Addendum 36 – Regulation No. 37

Revision 7 - Amendment 7

Supplement 44 to the 03 series of amendments – Date of entry into force: 8 October 2015

Uniform provisions concerning the approval of filament lamps for use in approved lamp units of power-driven vehicles and of their trailers

Category H19

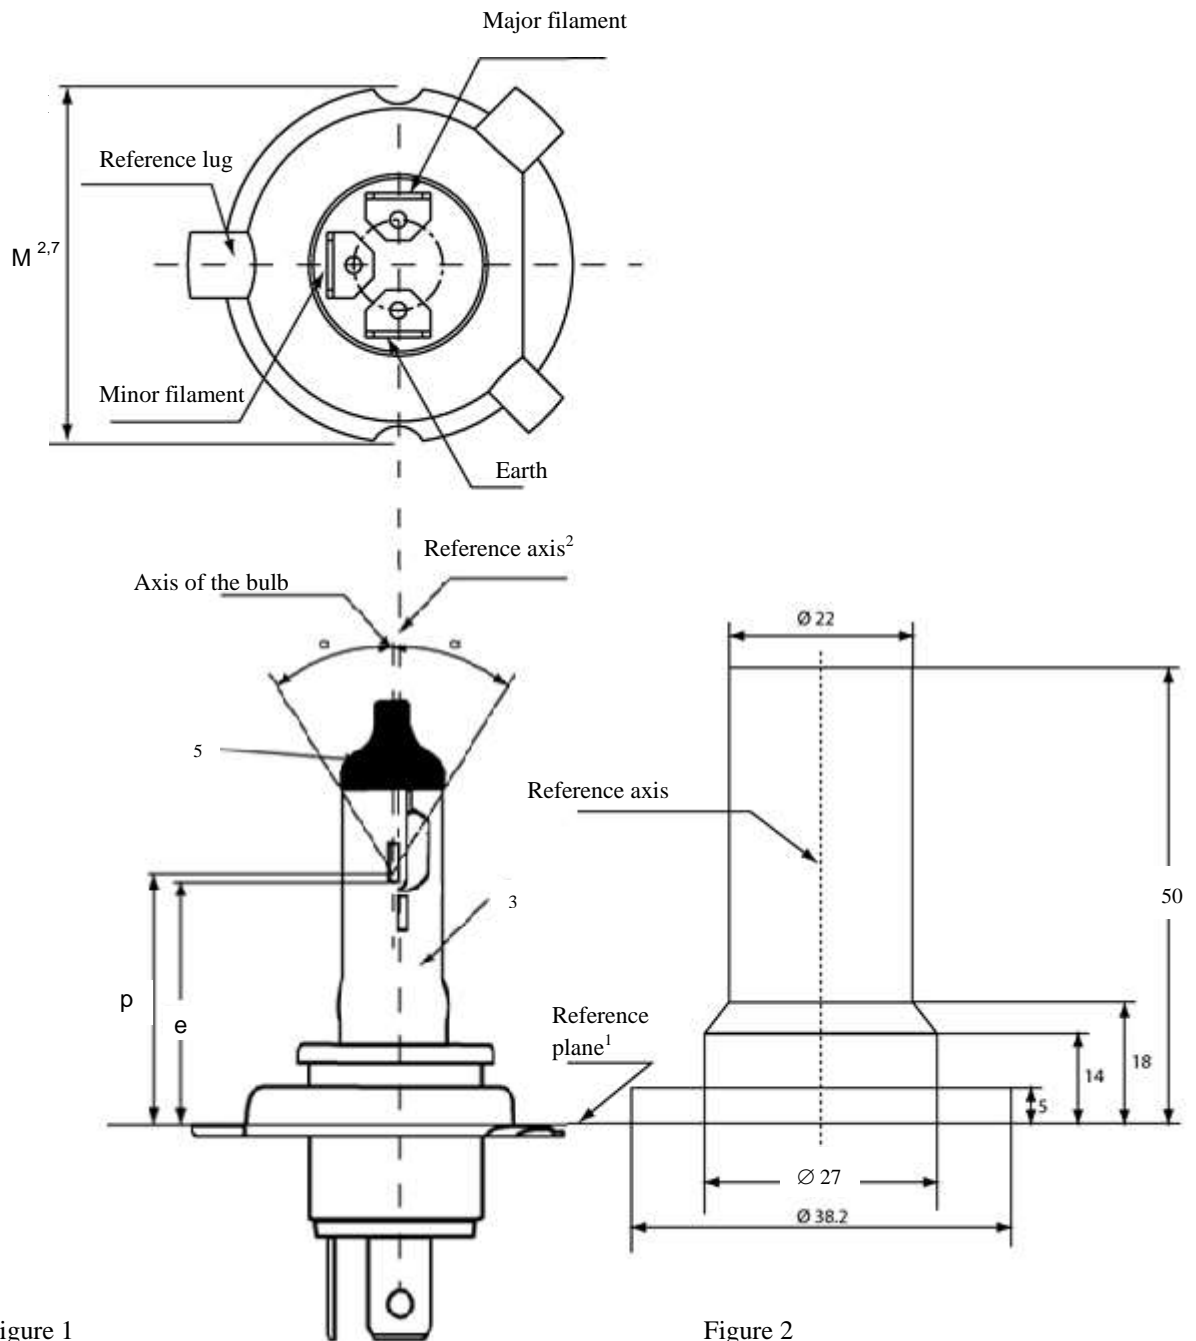
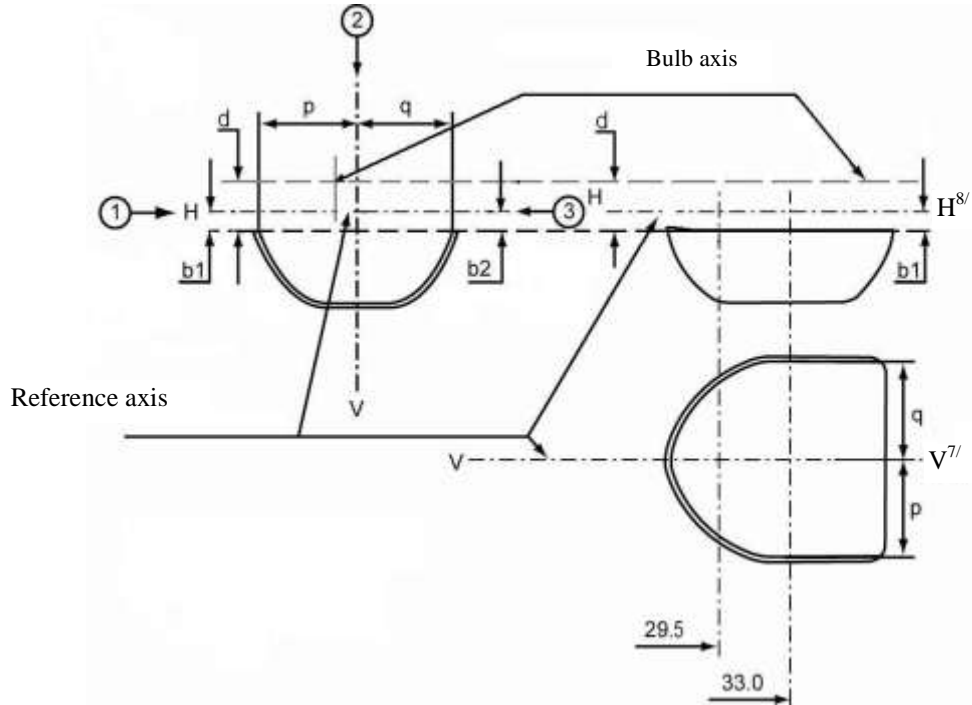
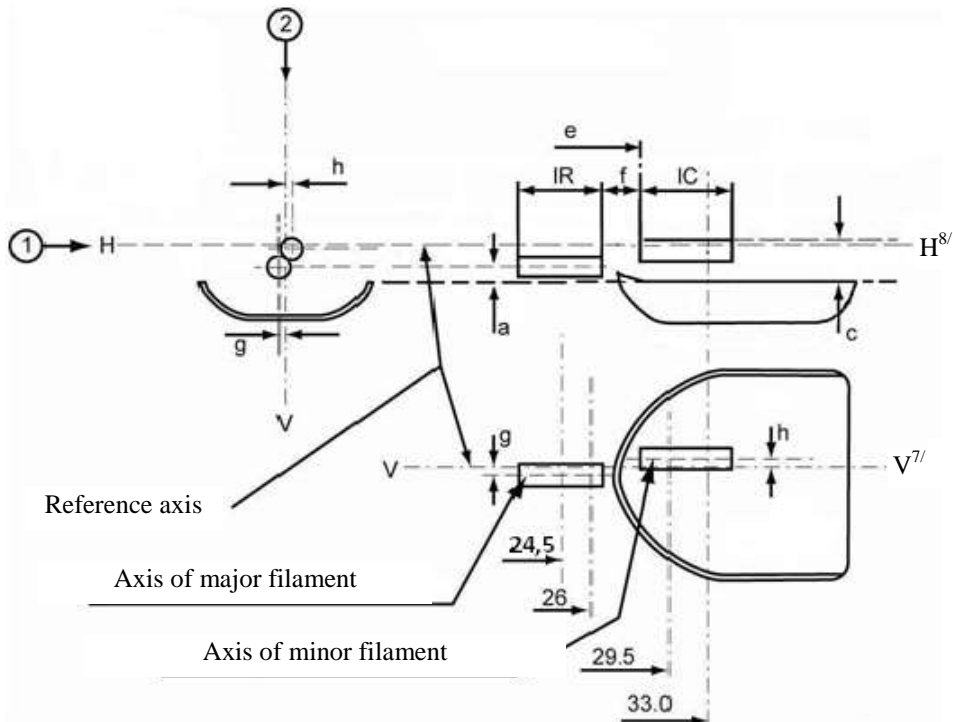
After sheet H17/6, add new sheets H18/1 to H18/4, H19/1 to H19/5 and H20/1 to H20/4, to read (see following pages; one page per sheet):

<i>Dimensions in mm</i>		<i>Filament lamps of normal production</i>		<i>Standard filament lamp</i>	
		<i>12 V</i>		<i>12 V</i>	
e		28.5 + 0.35 / - 0.15		28.5 + 0.20 / - 0.0	
p		28.95		28.95	
α		max. 45°		max. 45°	
Cap PU43t-3 in accordance with IEC Publication 60061 (sheet 7004-171-1)					
Electrical and photometric characteristics					
Rated values	Volts	12 ⁶		12 ⁶	
	Watts	60	55	60	55
Test values	Volts	13.2	13.2	13.2	13.2
Objective values	Watts	72 max.	68 max.	72 max.	68 max.
	Luminous flux	1 750 ± 10%	1 200 ± 10%		
Reference luminous flux at approximately			13.2 V	1 750	1 200

Reference*	Dimension**	Tolerance	
		Filament lamps of normal production	Standard filament lamp
a/26.0	0.7	±0.30	±0.20
a/24.5	0.7	±0.40	±0.20
b1/29.5	1.0	±0.30	±0.25
b1/33.0	b1/29.5 mv	±0.30	±0.15
b2/29.5	1.0	±0.30	±0.25
b2/33.0	b2/29.5 mv	±0.30	±0.15
c/29.5	1.7	±0.25	±0.15
c/33	c/29.5 mv	±0.25	±0.15
d	min. 1.1	-	-
e ¹¹	28.5	+0.35 / -0.15	+0.20 / -0.0
f ^{9, 10, 11}	1.4	±0.30	±0.15
g/26.0	0	±0.40	±0.30
g/24.5	0	±0.50	±0.25
h/29.5	0	±0.40	±0.25
h/33.0	h/29.5 mv	±0.30	±0.15
IR ^{9, 12}	4.0	±0.60	±0.30
IC ^{9, 10}	5.2	±0.60	±0.30
p/33.0	Depends on the shape of the shield	-	-
q/33.0	(p+q)/2	±0.60	±0.30

- 1 The reference plane is the plane formed by the seating points of the three lugs of the cap ring.
- 2 The reference axis is perpendicular to the reference plane and passes through the centre of the circle of diameter "M".

- 3 The light emitted from standard filament lamps and from normal production lamps shall be white.
- 4 The bulb and supports shall not exceed the envelope as in Figure 2.

- 5 The obscuration shall extend at least as far as the cylindrical part of the bulb. It shall also overlap the internal shield when the latter is viewed in a direction perpendicular to the reference axis.

- 6 The value indicated in the left hand column relate to the major filament. Those indicated in the right-hand column relate to the minor filament.
- 7 Plane V-V is the plane perpendicular to the reference plane and passing through the reference axis and through the intersection of the circle of diameter "M" with the axis of the reference lug.

- 8 Plane H-H is the plane perpendicular to both the reference plane and plane V-V and passing through the reference axis.
- 9 The end turns of the filament are defined as being the first luminous turn and the last luminous turn that are at substantially the correct helix angle.

- 10 For the minor filament, the points to be measured are the intersections, seen in direction 1, of either the lateral edge of the shield or the filament axis with the outside of the end turns defined under note 9.

- 11 "e" denotes the distance from the reference plane to the beginning of the minor filament as defined above.
- 12 For the major filament the points to be measured are the intersections, seen in direction 1, of a plane, parallel to plane H-H and situated at a distance of 0.3 mm below it, with the end turns defined under note 9.

Sheet PR21/5W/1, the following drawing,

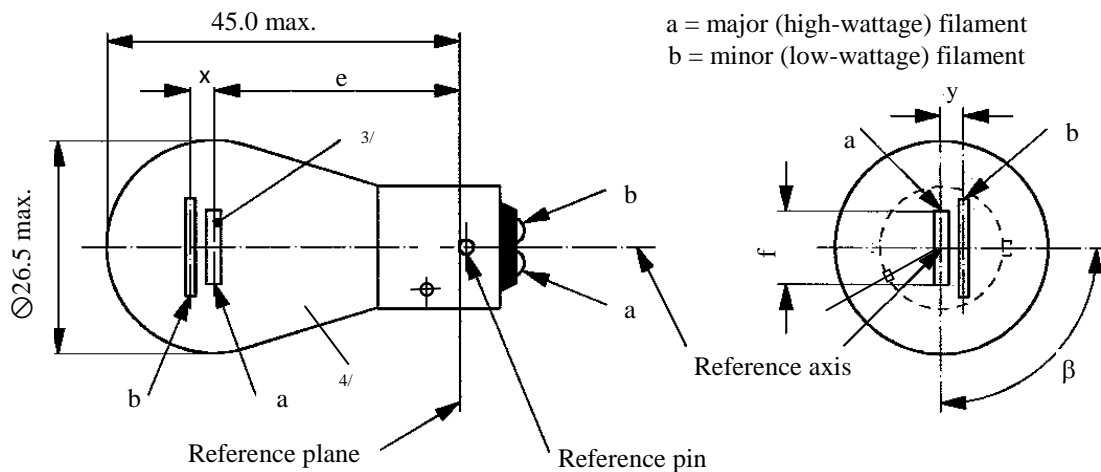
amend to read:

"2.4. Restricted colour boundaries.

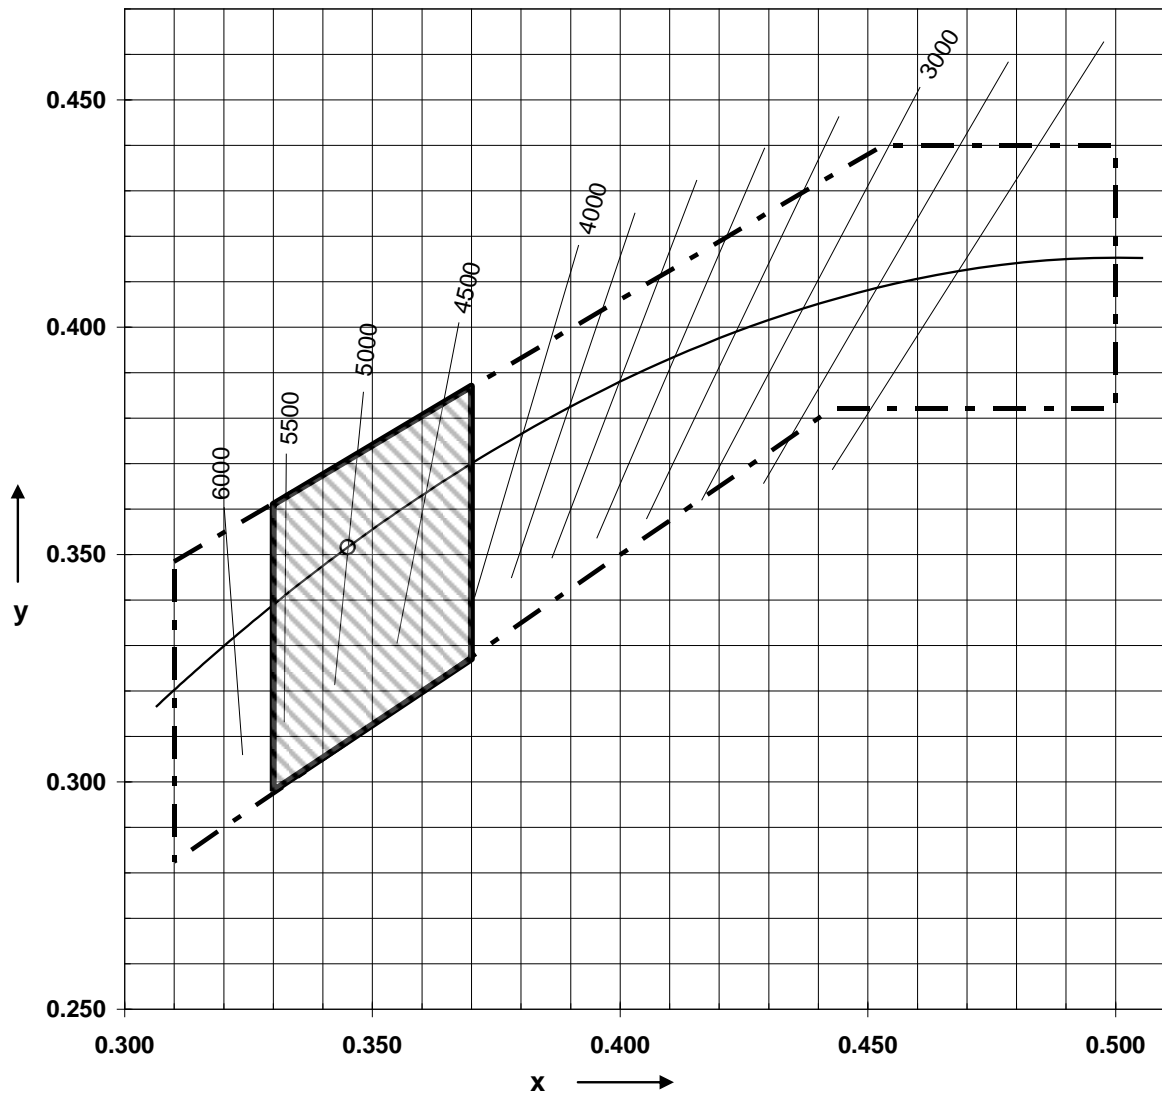
Insert a new paragraph 2.4., to read:

The following figure shows the colour tolerance area for the colour white (within the dashed lines) and the restricted tolerance area for the filament light source H20 (shaded area within the solid lines) in the CIE chromaticity coordinate system (x, y).
